**Comments on the CA Consultation Paper  
“Arrangements for Assignment of the Spectrum in the 3.4-3.6 GHz Band  
for the Provision of Public Mobile Services and  
the Related Spectrum Utilisation Fee”**

AsiaSat, 13 June 2018

Figure 1 LNAs in a 6.3m antenna in AsiaSat Tai Po earth station

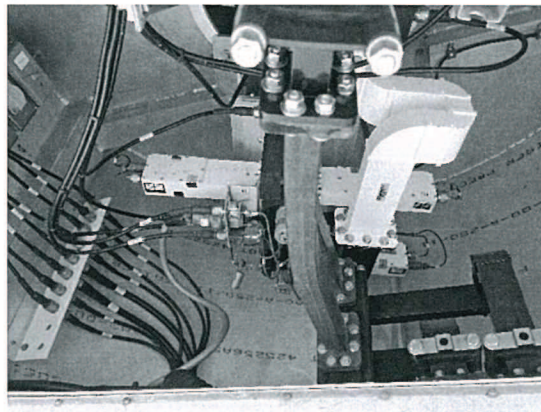
Figure 1 shows a 6.3 m antenna in AsiaSat Tai Po earth station. The dimension of a typical C-band BPF operating in 3.7-4.2 GHz is about 120mm×100mm×70mm<sup>3</sup>. It can be seen that there is no room to insert an extra bandpass filter before a LNA at all. Even a LNA embedded with a BPF is commercially available now, the cost to replace the existing LNAs (three in total in a dual-pol antenna, of which one is for backup) involving hardware, modifying the system, installation etc. will far exceed the amount of the subsidy proposed by OFCA.

It should also be noted that the quality of the services provided by AsiaSat must meet certain quality objectives. Insertion of a BPF in between the feed horn and LNB/LNA of earth station antennas will increase the loss before the front-end amplifier and degrade the quality of the services we provide. For example, a BPF with an insertion loss of 1 dB will cause 1-2 dB degradation on satellite link performance. To achieve the same service quality, we therefore would have to replace the antenna with a larger one and in this case, costs way beyond those of the BPF would be incurred.
